NOTICE OF DECISION

CLASS 3 SITE PLAN REVIEW / CLASS 2 ADJUSTMENT CASE NO.: SPR-ADJ25-13

APPLICATION NO.: 24-124647-PLN

Summary: Proposed redevelopment of an existing off-street parking area and change of use within an existing building

1 SITE PLAN
SCALE: 1" = 20'-0"

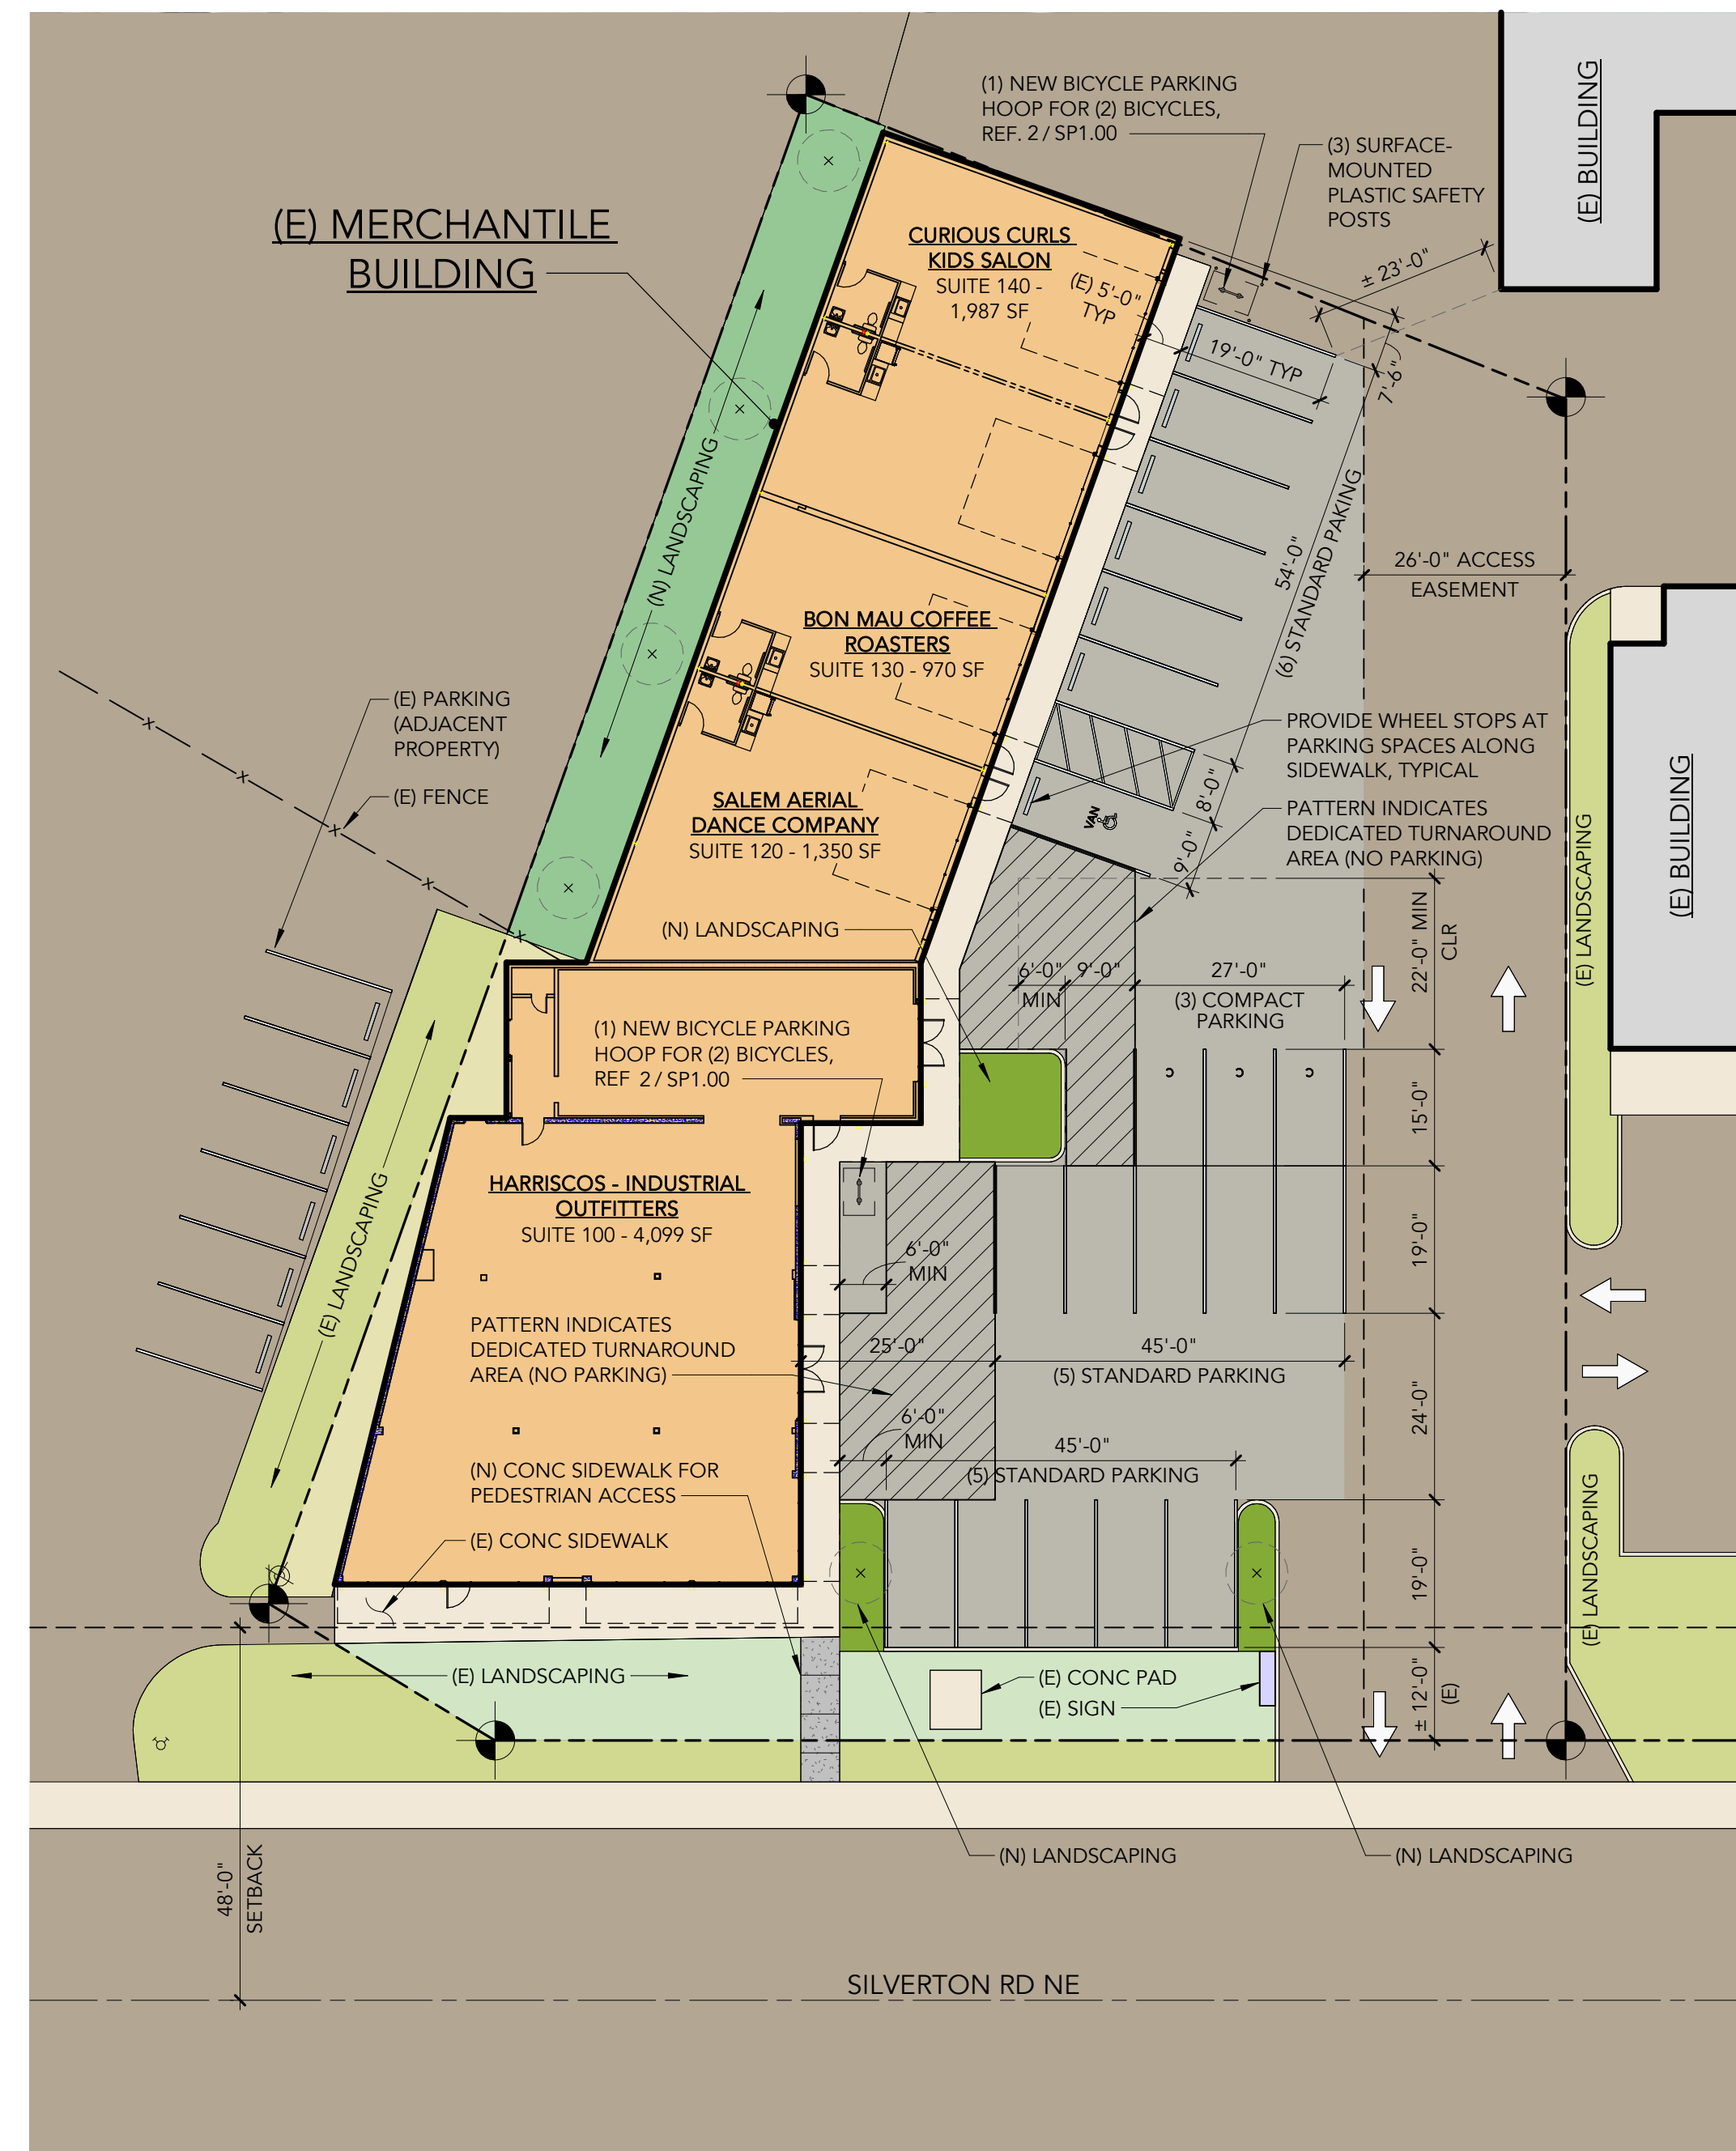
Finding: The existing building's footprint is not proposed to be modified as part of this development. The existing eastern off-street parking area was previously resurfaced without site plan review approval and the applicant is proposing to reconfigure the parking area to add turnaround areas and landscaping. The existing resurfaced parking area is projecting into the special setback, so the applicant is seeking a Class 2 Adjustment to eliminate the street

Finding: The existing structure is located along the western portion of the site and is not proposed to be modified as part of this development. Along the eastern property, there is a 26-foot-wide flag lot accessway easement which the rules of measurement for setback under SRC 112.050 (c) requires setbacks to be measured from the most interior access easement line. The existing resurfaced and proposed reconfigured off-street parking area directly abuts the accessway as such the applicant has sought a Class 2 Adjustment to eliminate the interior side setback. Along the northern property line, the resurfaced parking area will be setback five-feet from the northern property line without Type A landscaping. As the applicant is proposing to eliminate the landscaping required within the setback, the above-described Class 2 Adjustment applies, which is discussed in Section 7 of this report.

Finding: The application materials do not provide sufficient detail to determine compliance with this development standard. As such, the following is conditioned:

Finding: The applicant's site plan indicates that the off-street parking areas measure approximately 8,215 square feet in size requiring a minimum of 411 square feet of interior off-street parking area landscaping. As proposed, the plans show that 336 square feet or 4 percent of interior off-street parking landscaping will be provided outside of the 48-foot special setback along Silverton Road NE. As the off-street parking area will not meet the minimum required interior off-street parking, the applicant has sought a Class 2 Adjustment to reduce the minimum required interior landscaping required from 5 to 4 percent.

However, the bicycle parking area is located within a vehicle use area where parked bicycles can be impacted by vehicles maneuvering. As such, the following is conditioned to provide protection for bicycle parked within the proposed location.

Exclusive of the portion within the special setback along Silverton Road NE, the development site measures roughly 24,250 square feet requiring a minimum of 3,638 square feet of landscaping ($24,250 \times 0.15 = 3,637.5$). The development plans include a preliminary

landscaping plan indicating 1,931 square feet of total landscaping area outside of the special setback resulting in 7% of the development site being composed of landscaping. The applicant is seeking a Class 2 Adjustment to reduce the development site landscaping requirement from 15% to 7%.

Condition 1: At the time of building permit, the applicant shall provide details demonstrating that the lighting required under SRC 800.065(c) is provided for the required pedestrian connection.

Condition 3: The adjusted development standards, as approved in this zoning adjustment, shall only apply to the specific development proposal shown in the attached site plan. Any future development, beyond what is shown in the attached site plan, shall conform to all applicable development requirements, unless adjusted through a future land use action.

2 BICYCLE RACK DETAIL
SCALE: 3/4" = 1'-0"

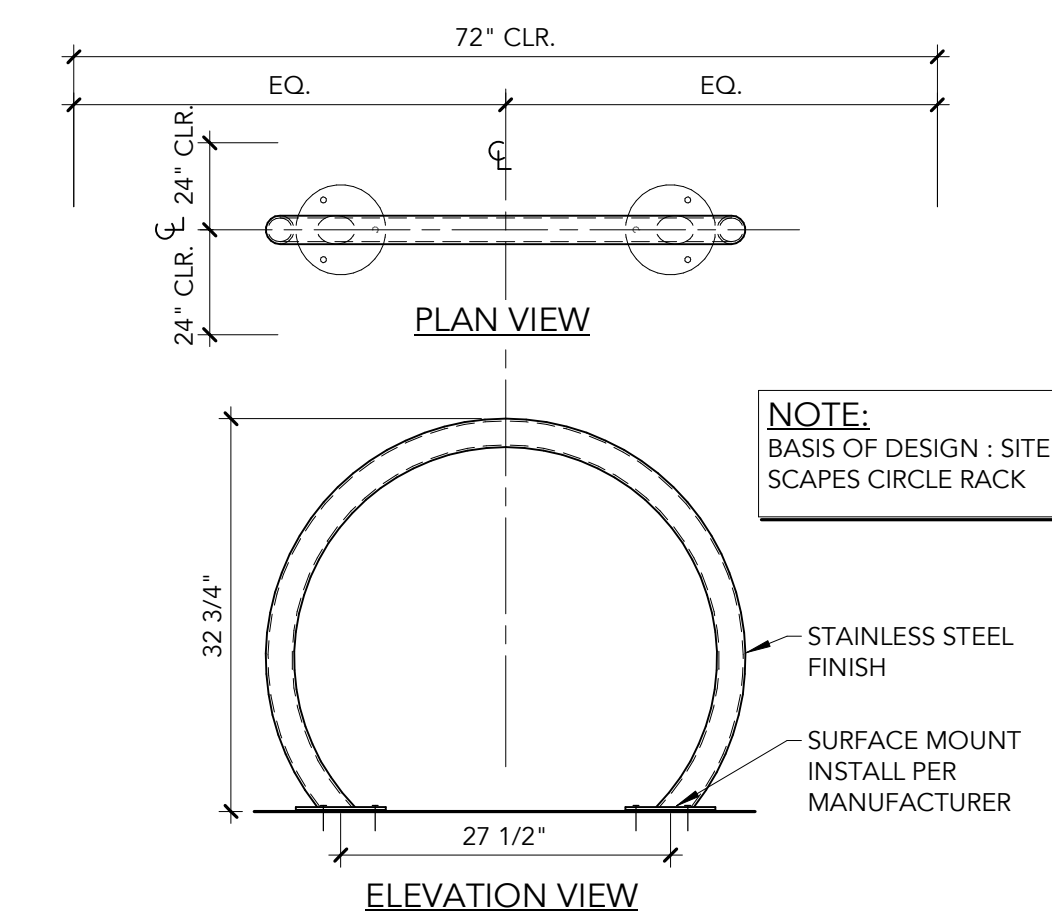
Finding: Bicycle parking spaces are required to be a minimum of six feet in length and one and half feet in width when the proposed bicycle racks are side-by-side. For horizontal spaces, the bike rack shall be centered along the long edge of the bicycle parking space. The proposed bicycle parking spaces are arranged with adequate dimensions to provide pedestrian passage for all four of the proposed spaces; the length of each proposed stall is at least six feet, with at least one and a half feet width between the side-by-side spaces, meeting the standards.

Finding: The site plan indicates inverted style bike racks will be provided. The proposed bike racks conform to material requirements of SRC 806.060(e).
